UNITED STATES  
NUCLEAR REGULATORY COMMISSION  
WASHINGTON, D. C. 20555

POINT BEACH NUCLEAR PLANT, UNIT NO. 1

Amendment No. 86  
License No. DPR-24

ATTACHMENT TO LICENSE AMENDMENT NOS. 86 AND 90  
TO FACILITY OPERATING LICENSE NOS. DPR-24 AND DPR-27  
DOCKET NOS. 50-266 and 50-301

Figure 15.2.1-1  
CORE DNB SAFETY LIMITS (TRANSITION CORE)  
POINT BEACH UNITS 1 & 2

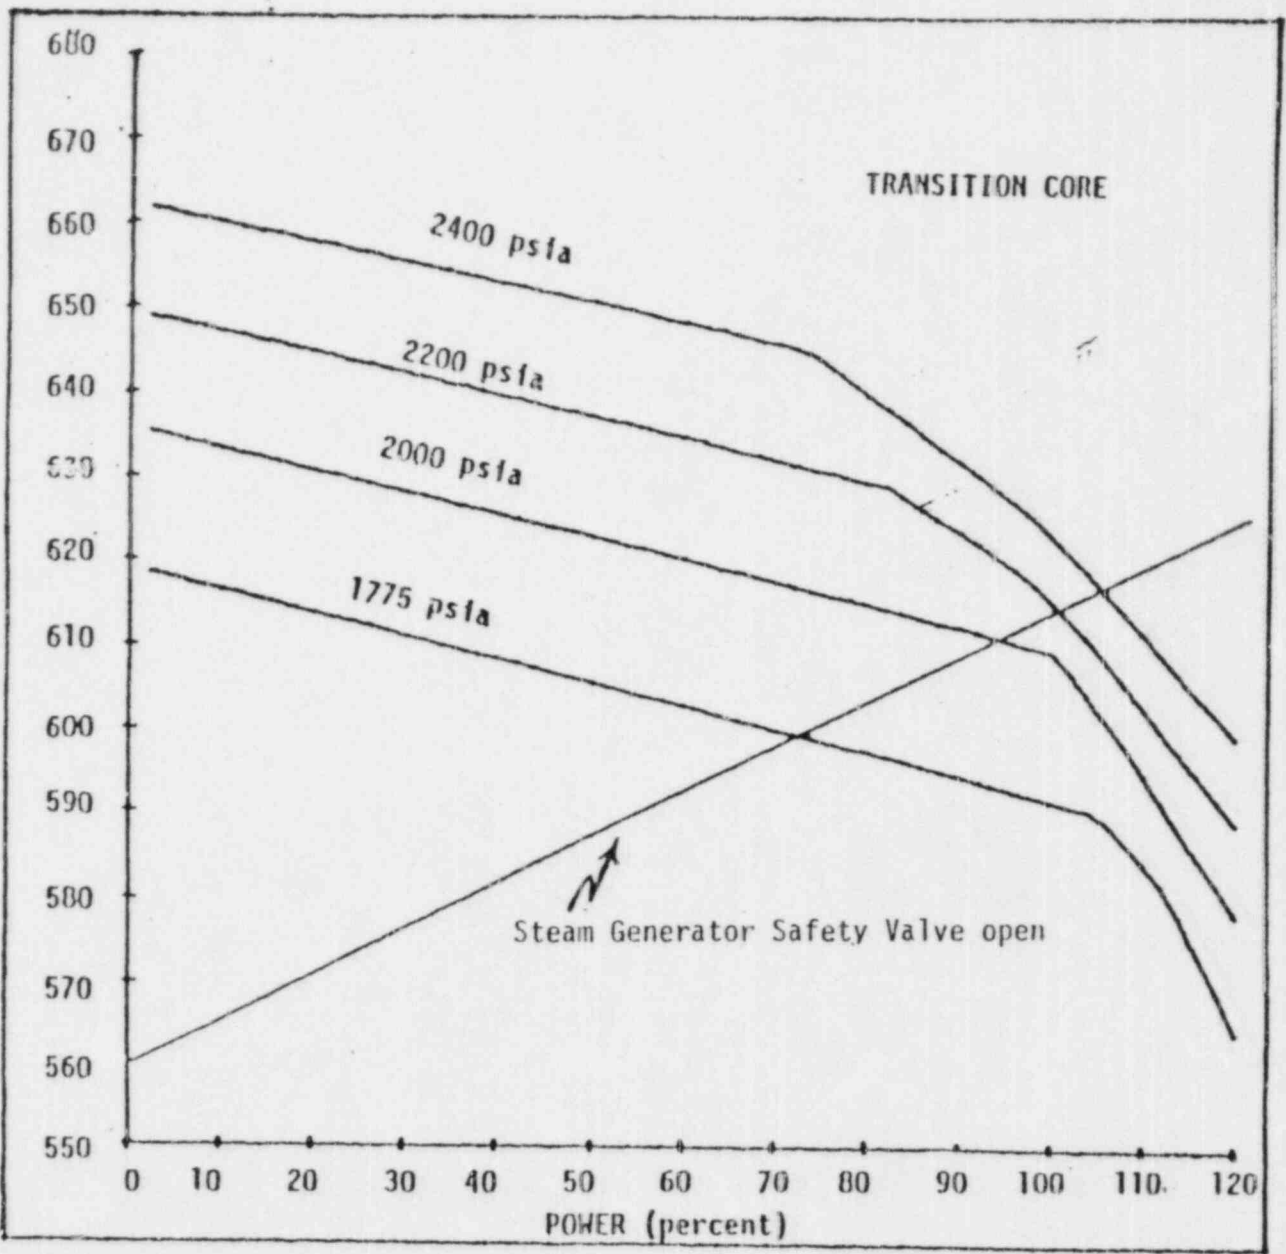
1. The combination of thermal power level, coolant pressure, and coolant temperature shall not exceed the limits shown in Figure 15.2.1-1 for a transition core\* and 15.2.1-2 for the full optimized fuel assembly (OFA) core. The safety limit is exceeded if the point defined by the combination of reactor coolant system average temperature and power level is at any time above the appropriate pressure line.

The curves of Figure 15.2.1-1 are applicable to transition cores. The W-3 correlation is used to generate these curves. The DNBR limit of this correlation is shown to be met in plant safety analyses using values of input parameters with uncertainties considered at fixed conservative values.

Figure 15.2.1-2  
CORE DNB SAFETY LIMITS (OPTIMIZED FUEL)  
POINT BEACH UNITS 1 & 2

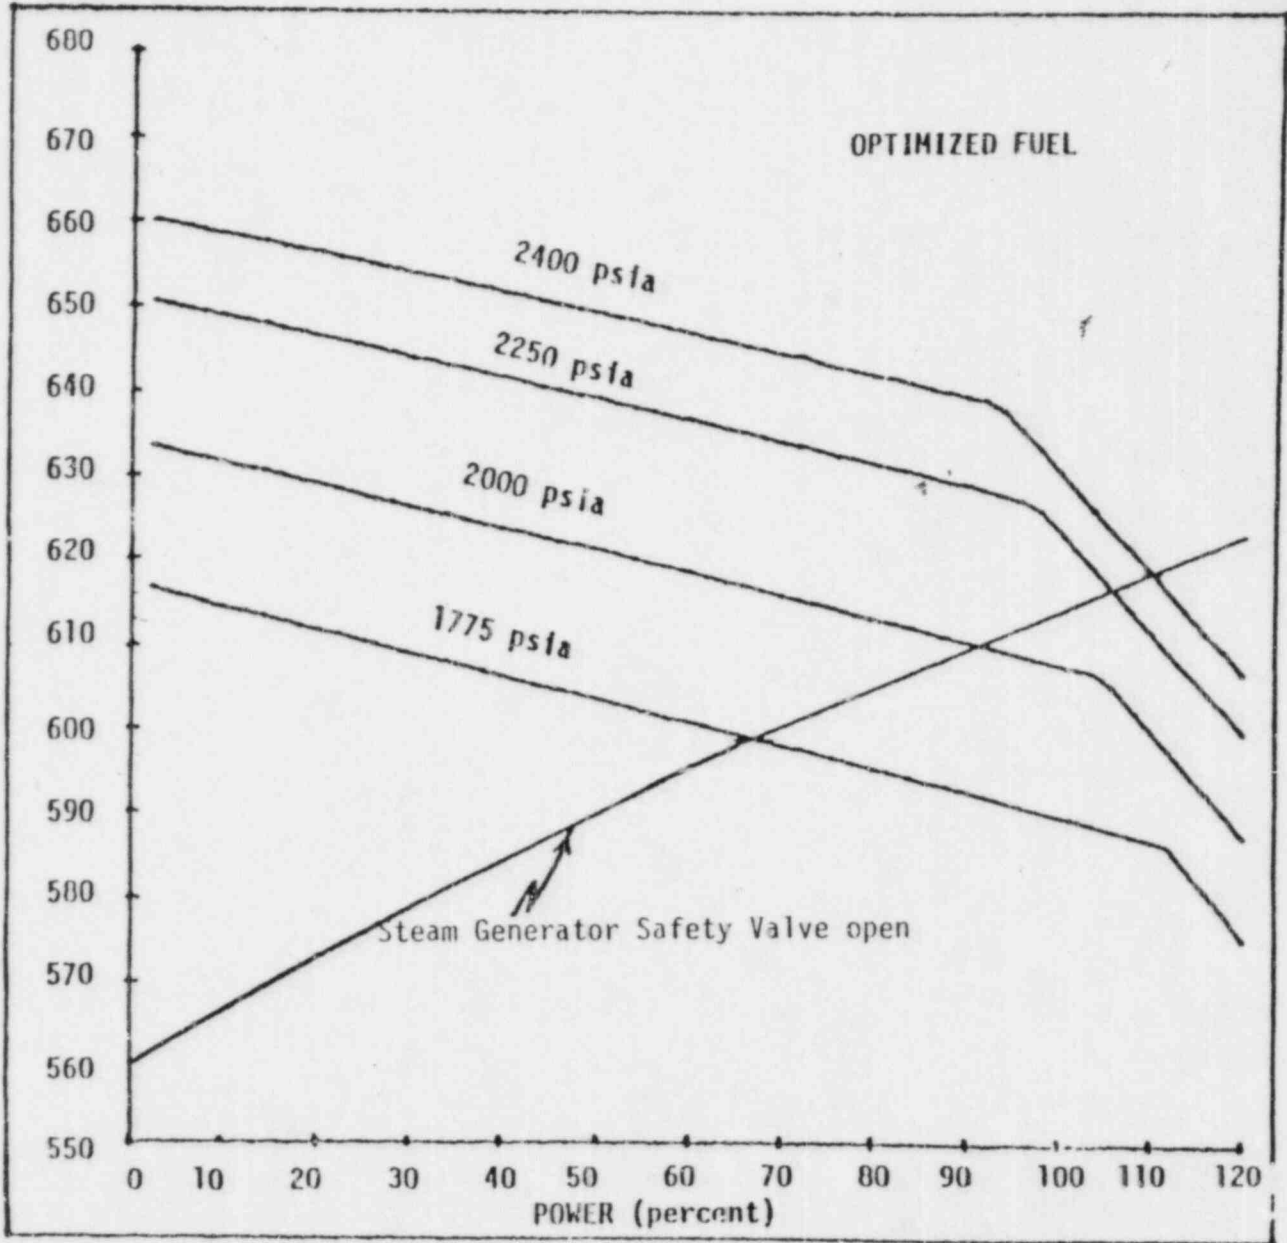
The curves of Figure 15.2.1-2 are applicable for a full core of 14x14 OFA. The WRB-1 correlation is used to generate these curves. Uncertainties in plant parameters are statistically convoluted to determine the plant DNBR uncertainty. This DNBR uncertainty, combined with the correlation DNBR limit, establishes a value of design limit DNBR. This value of design limit DNBR is shown to be met in plant safety analyses, using values of input parameters considered at their nominal values.

FIGURE 15.3.10-3  
 POINT BEACH UNITS 1 & 2  
 HOT CHANNEL FACTOR NORMALIZED OPERATING ENVELOPE

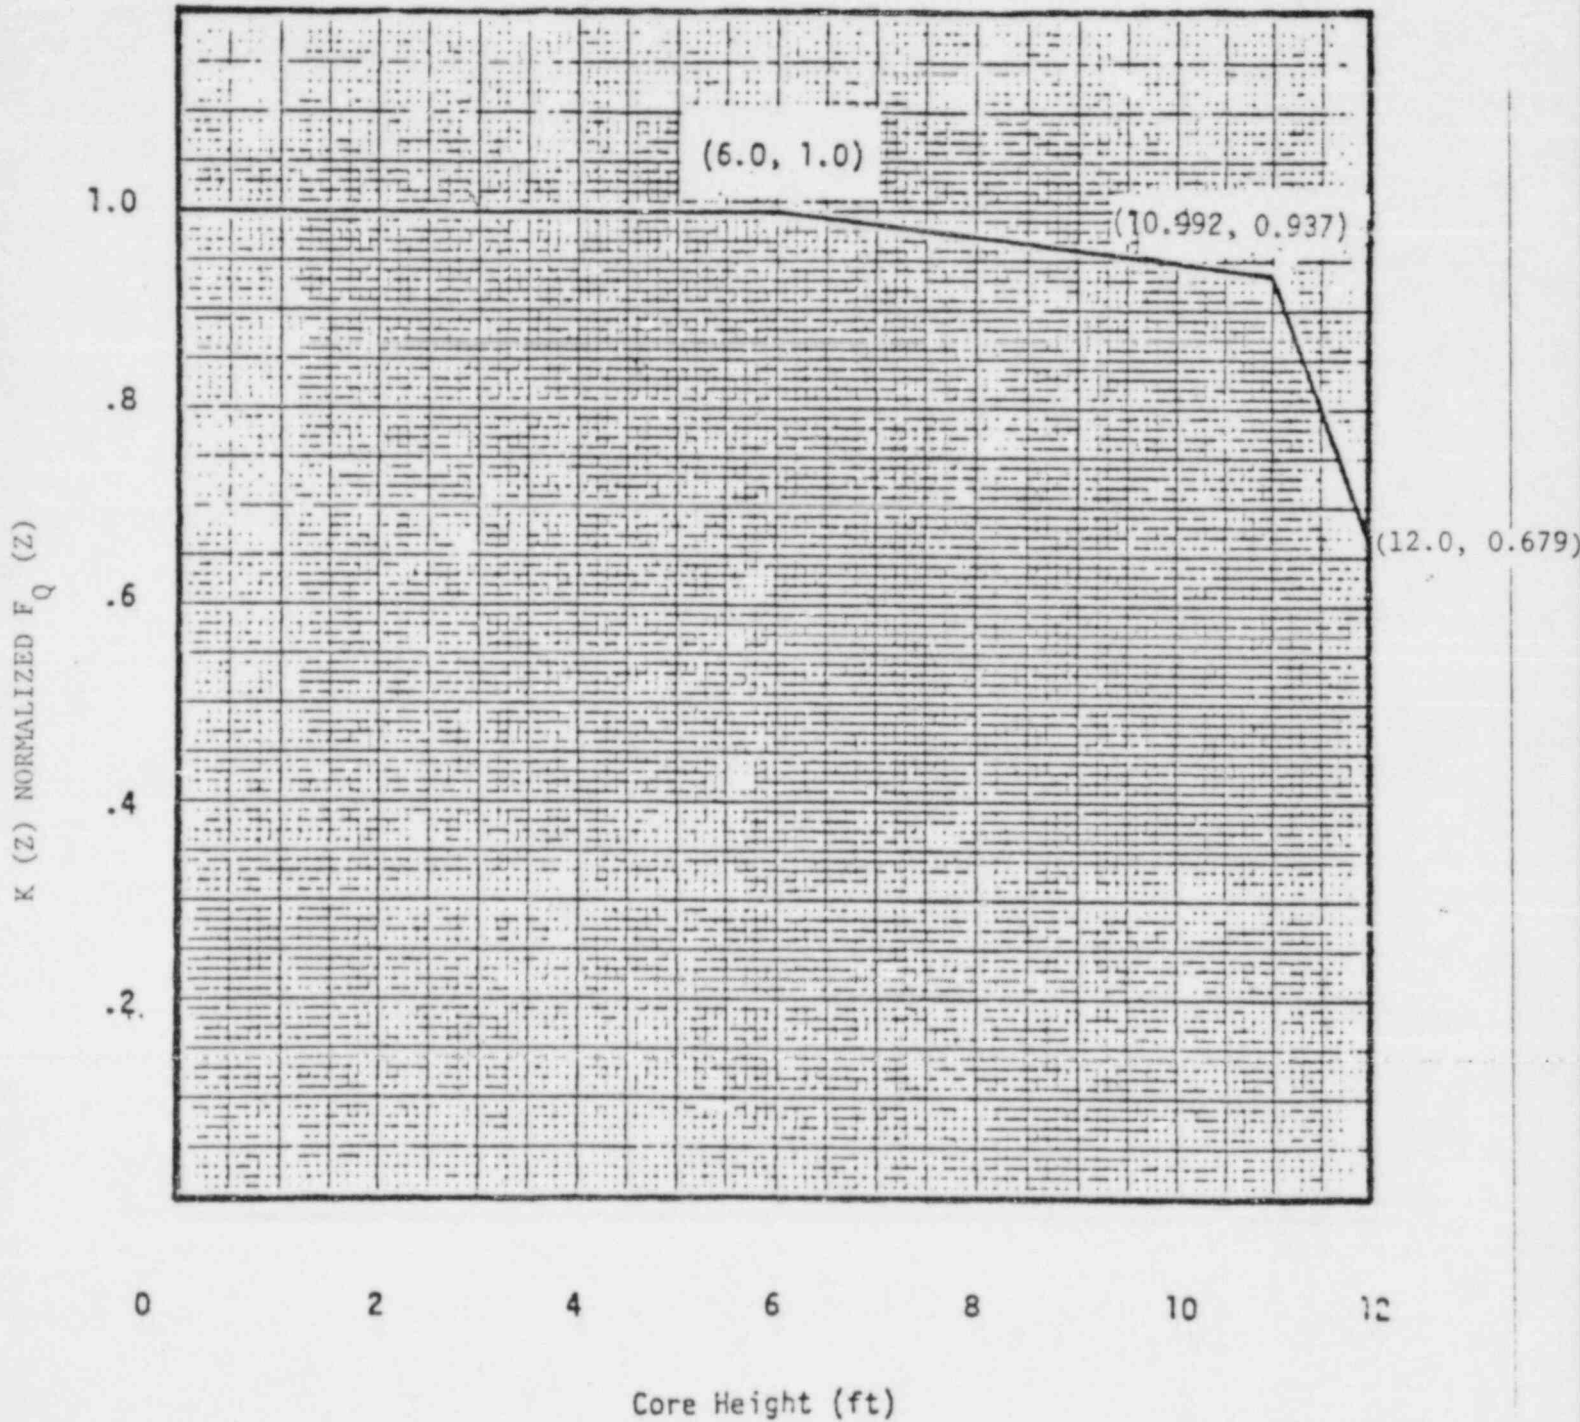
Where P is the fraction of full power at which the core is operating, K(Z) is the function in Figure 15.3.10-3 and Z is the core height location of  $F_Q$ .

An upper bound envelope of 2.21 times the normalized peaking factor axial dependence of Figure 15.3.10-3 consistent with the Technical Specifications on power distribution control as given in Section 15.3.10 was used in the LOCA analysis. The results of the analyses based on this upper bound envelope indicate a peak clad temperature of less than the 2200°F limit. When an  $F_Q$  measurement is taken, both experimental error and manufacturing tolerance must be allowed for. Five percent is the appropriate allowance for a full core map taken with the moveable incore detector flux mapping system and three percent is the appropriate allowance for manufacturing tolerance. In the design limit of  $F_{\Delta H}^N$ , there is eight percent allowance for uncertainties which means that normal operation of the core is expected to result in a design  $F_{\Delta H}^N \leq 1.58/1.08$ . The logic behind the larger uncertainty in this case is that (a) normal perturbations in the radial power shape (i.e., rod misalignment) affect  $F_{\Delta H}^N$ , in most cases without necessarily affecting  $F_Q$ , (b) while the operator has a direct influence on  $F_Q$  through movement of rods, and can limit it to the desired value, he has no direct control over  $F_{\Delta H}^N$  and (c) an error in the predictions for radial power shape which may be detected during startup physics tests can be compensated for in  $F_Q$  by tighter axial control, but compensation for  $F_{\Delta H}^N$  is less readily available. When a measurement of  $F_{\Delta H}^N$  is taken, experimental error must be allowed for and four percent is the appropriate allowance for a full core map taken with the moveable incore detector flux mapping system.

FIGURE 15.3.10-4  
FLUX DIFFERENCE  
OPERATING ENVELOPE  
POINT BEACH UNITS 1 & 2

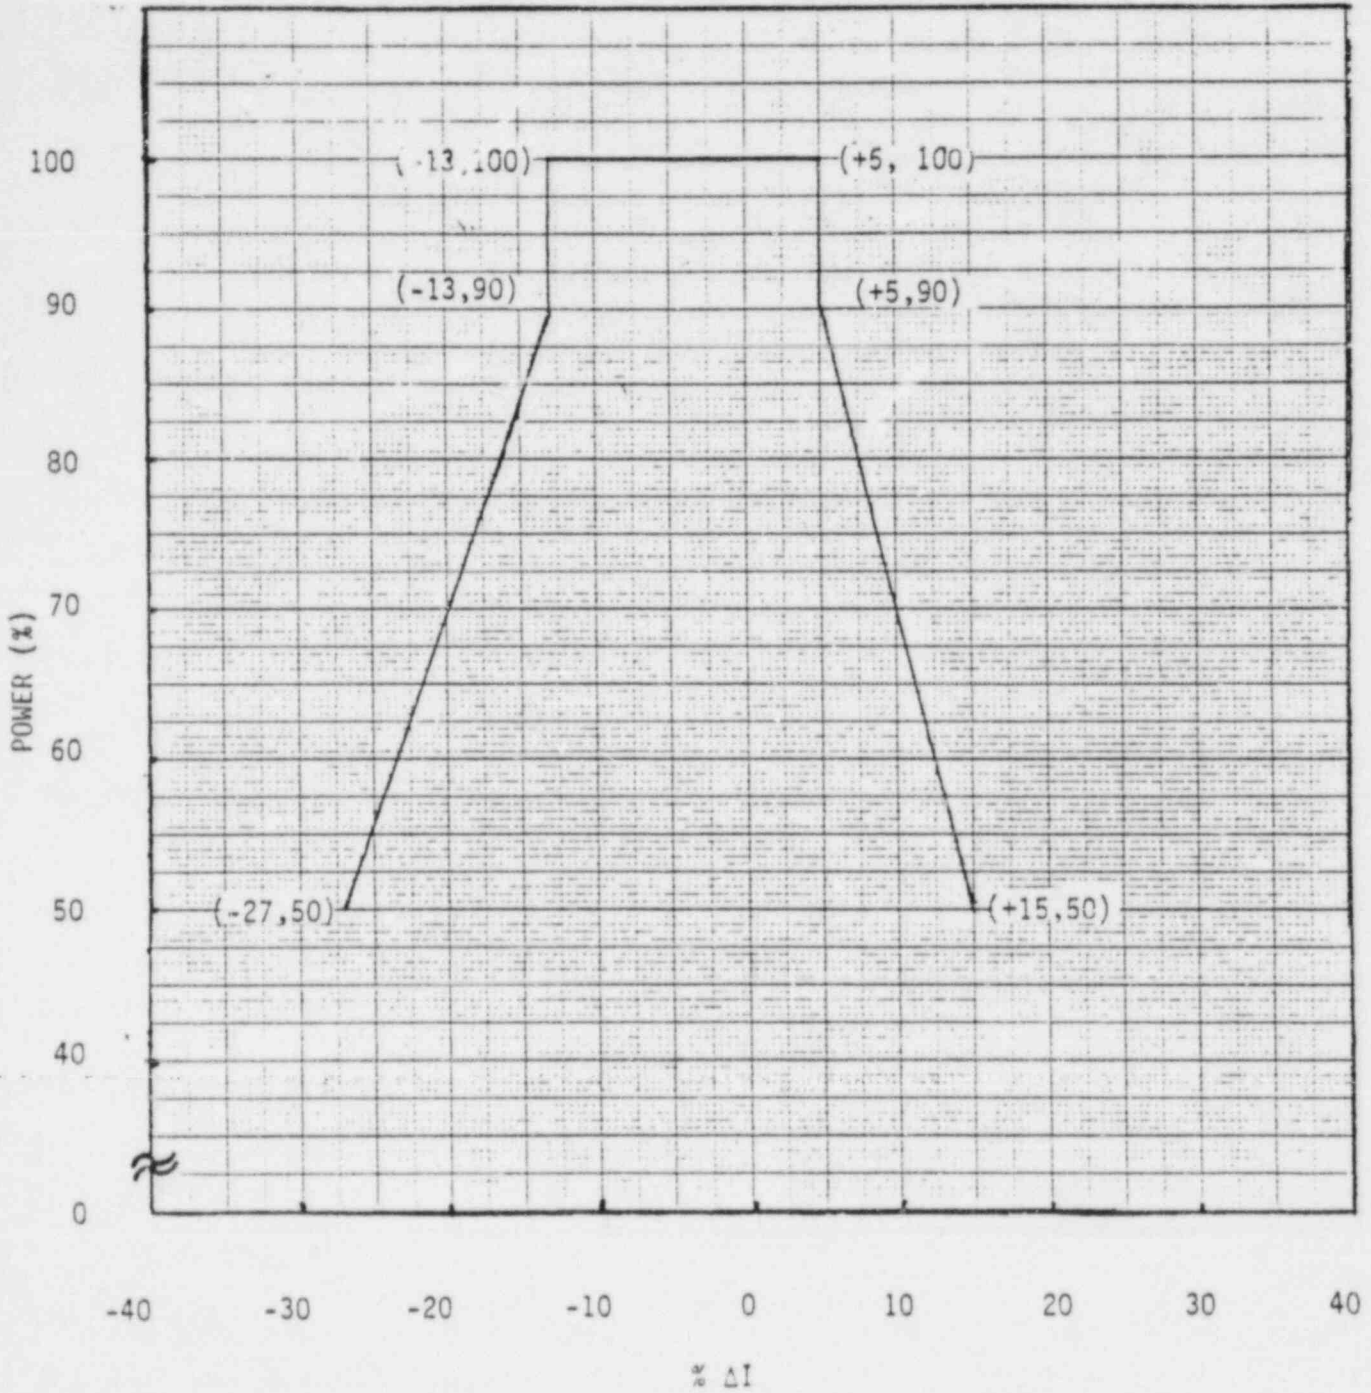
2. a. The indicated axial flux difference (AFD) shall be maintained within the allowed operational space defined by Figure 15.3.10-4 except during physics tests. The physics test exemption applies provided that the thermal power is less than or equal to 85% of Rated Power and the limits of Specification 15.3.10.B.1.a are satisfied. During suspension of the specification, the thermal power shall be determined to be less than or equal to 85% of rated thermal power at least once per hour. In addition, the surveillance requirements of 15.3.10.B.1.b shall be performed at least once per 12 hours.

- b. If the indicated AFD deviates from the Figure 15.3.10-4 limits, the AFD shall be restored to within the Figure 15.3.10-4 limits within 15 minutes. If this cannot be accomplished, then reactor power shall be reduced until the AFD is within the envelope or the power level is less than 50% of Rated Power. Normally the rate of power reduction is 15% per hour. Once AFD has been returned to and maintained within the operating envelope, power level is no longer restricted. If it is necessary to reduce power to 50%, the Power Range Neutron Flux-High Trip Setpoints shall be reduced to less than or equal to 55 percent within the next 4 hours.

- c. A power increase to a level greater than 50% of Rated Power is contingent upon the indicated AFD being within the Figure 15.3.10-4 limits.
- d. Alarms shall normally be used to indicate non-conformance with the flux difference requirements of 15.3.10.B.2.a and 15.3.10.B.2.b. If the alarms are totally out of service,
